STERLING RANCH FILING 3

GRADING AND EROSION CONTROL PLANS

JUNE 2021
PCD FILING NO. : SP-20-003

VICINITY MAP
SCALE : 1"=1,000'

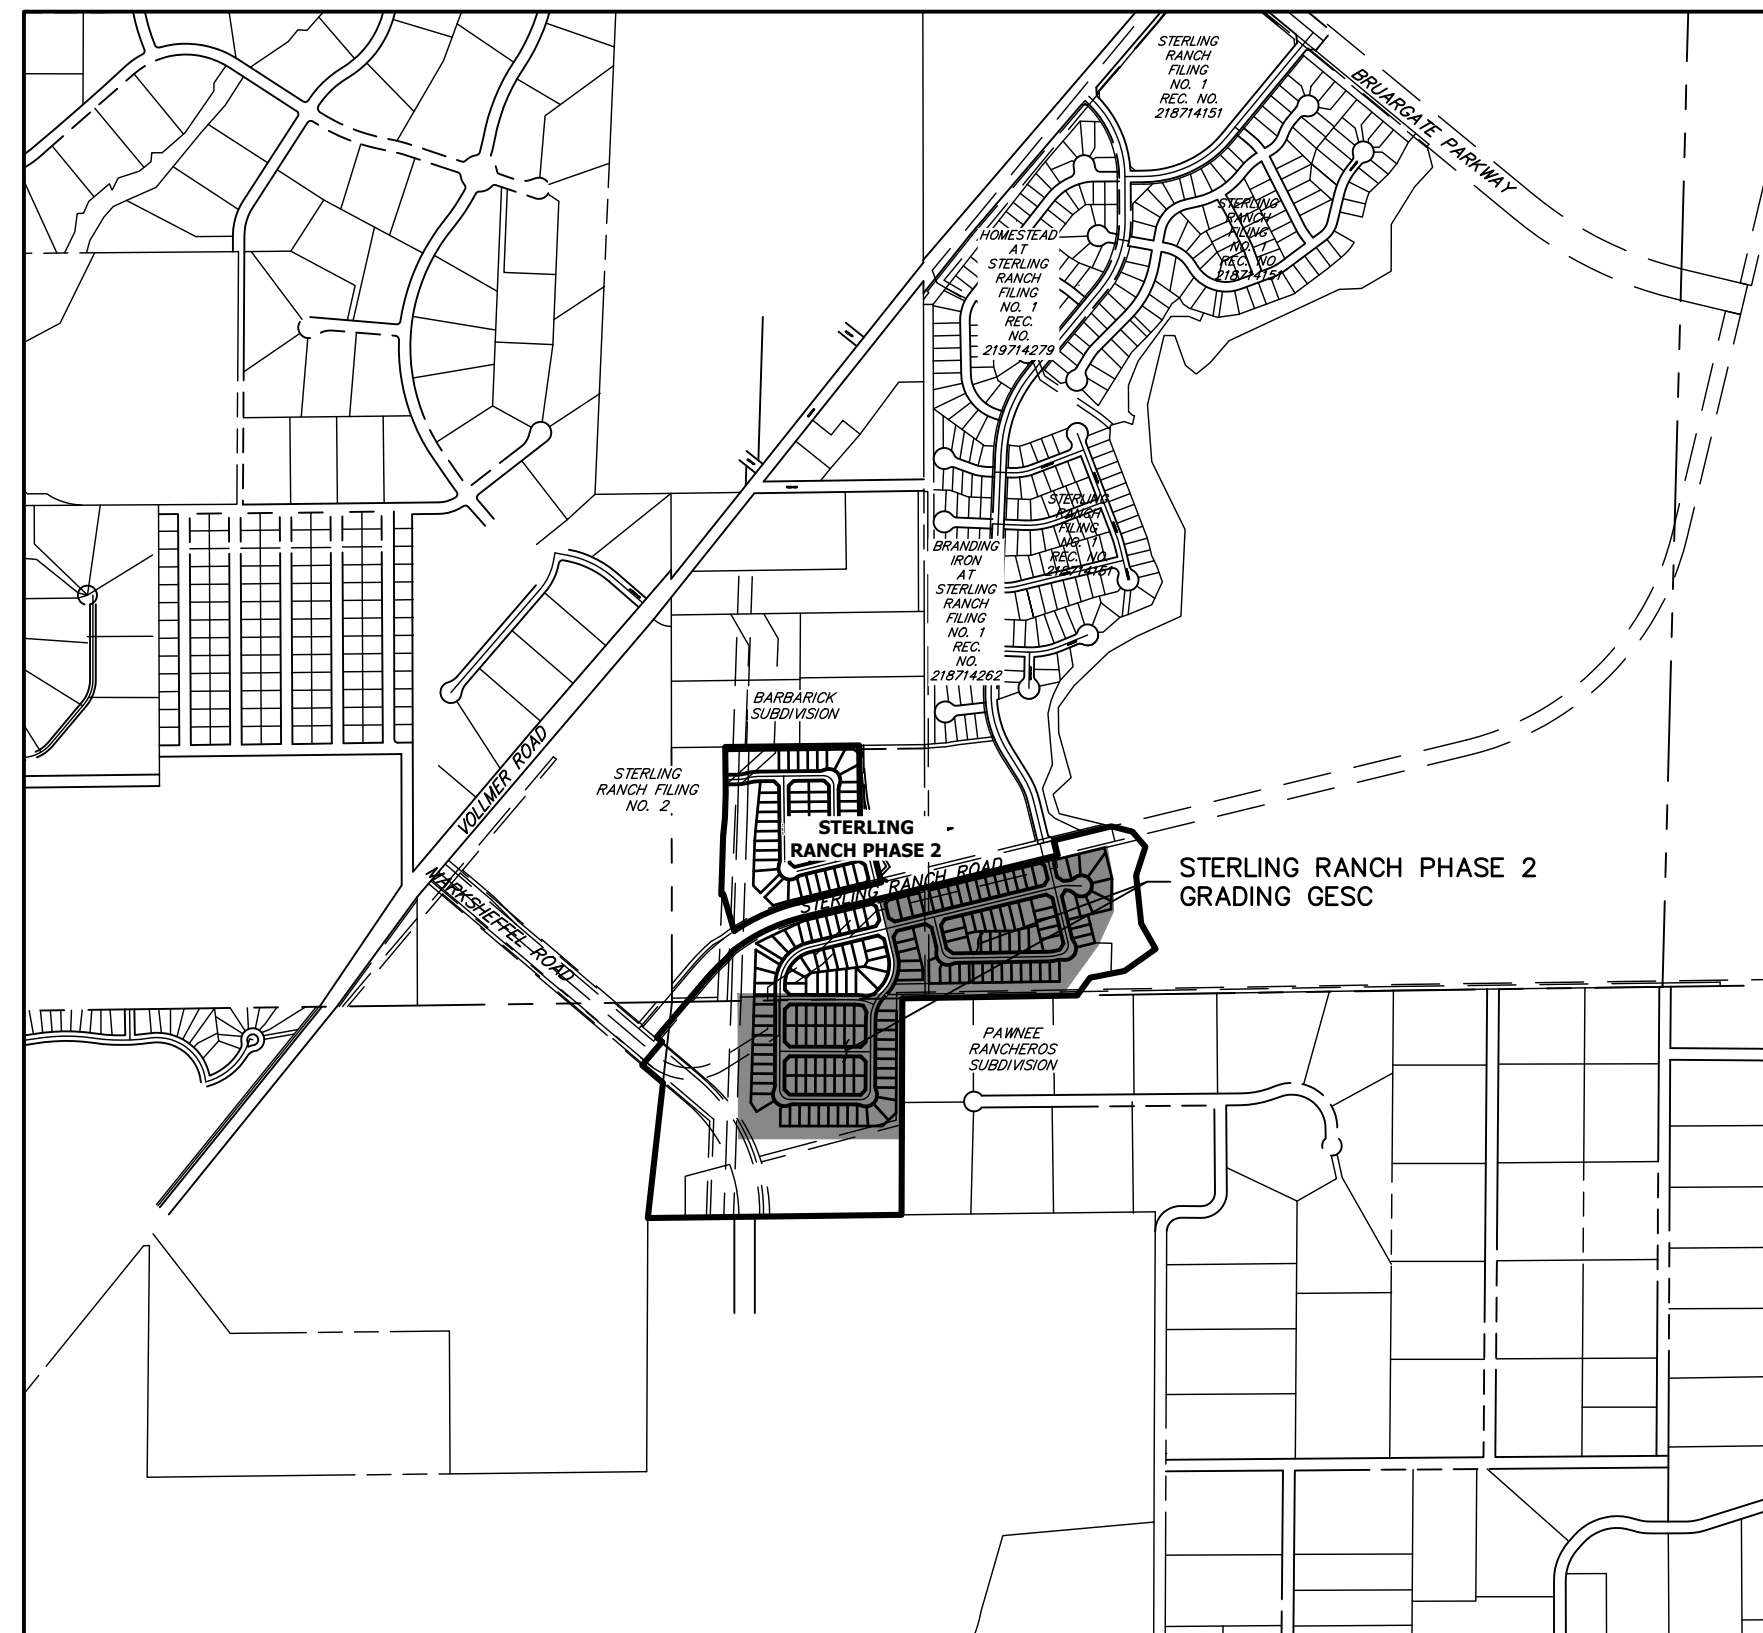
update?

LOT DRAINAGE TYPES AND SWALE DIRECTION
 NOT TO SCALE

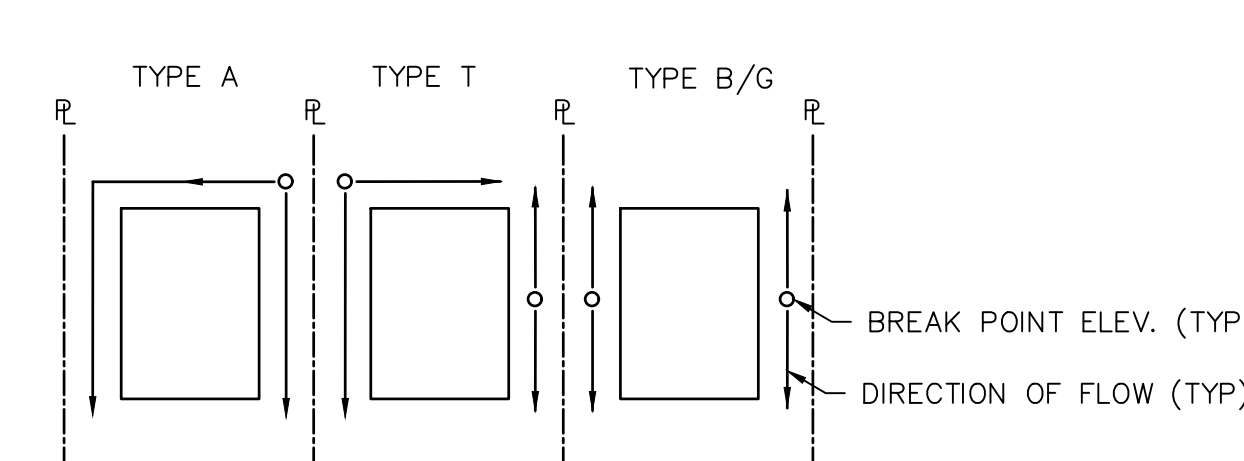
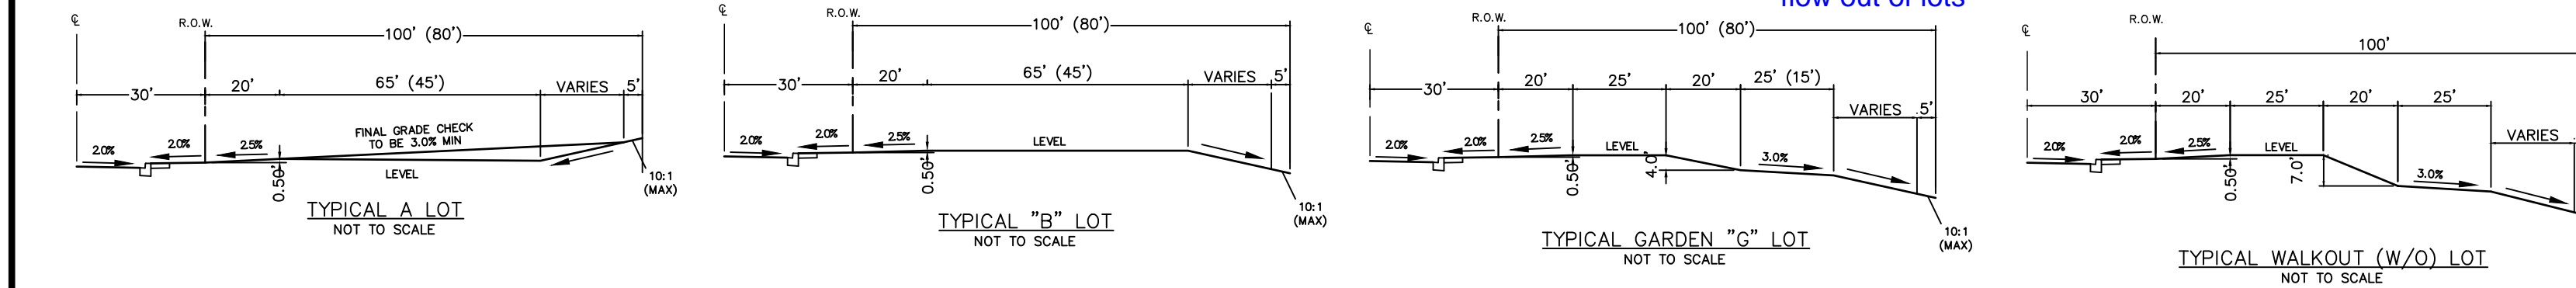
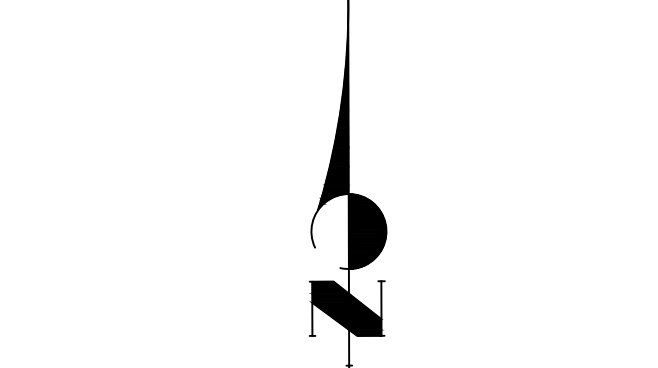
Are these notes correct?

Provide retaining wall details

GRADING AND EROSION CONTROL PLAN

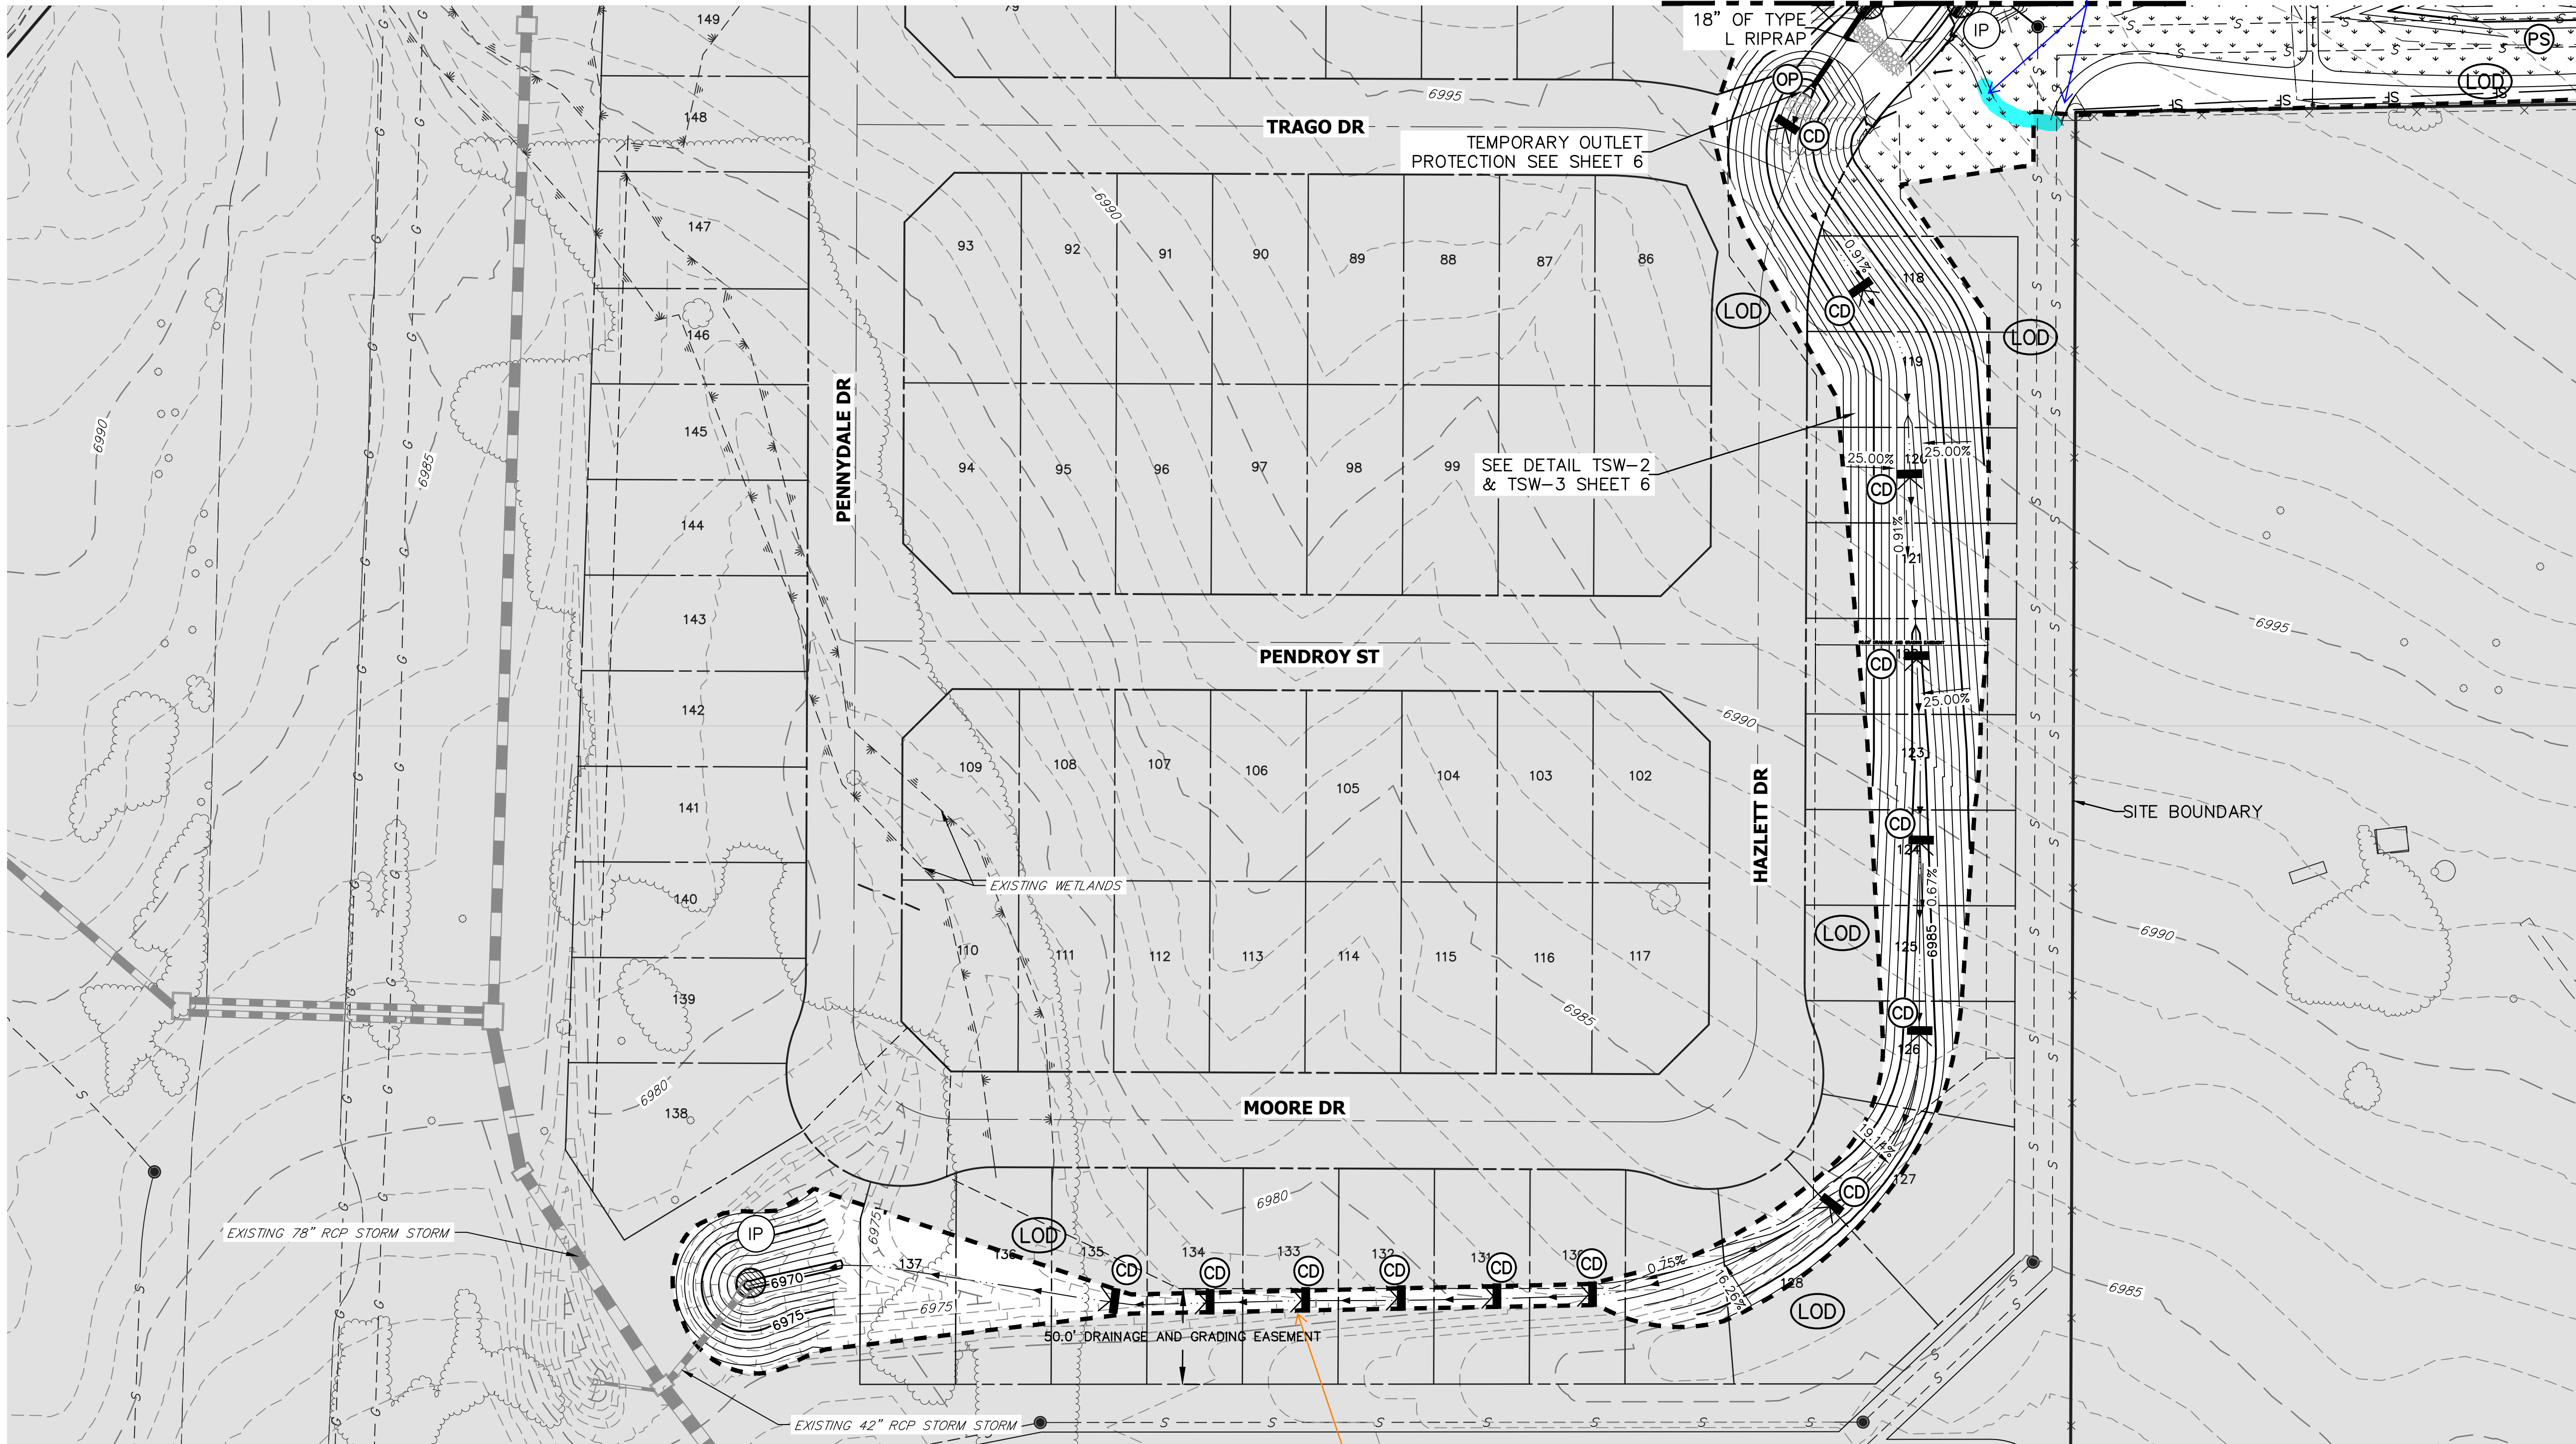
connect the trails?

GRADING AND EROSION CONTROL PLAN

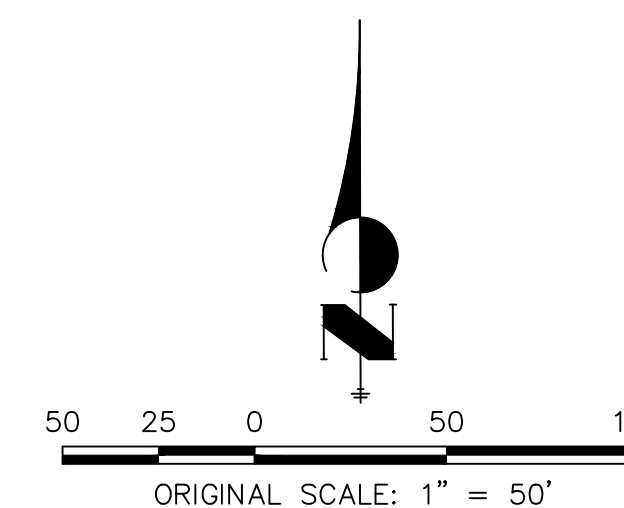
Specify type of check dams (rock checks shown in F&E Form). Include a detail for check dams in final sheets. Specify spacing (or criteria based on varying slopes) for check dams.

Also show location of straw bales since they are shown on F&E in addition to rock checks and IP.
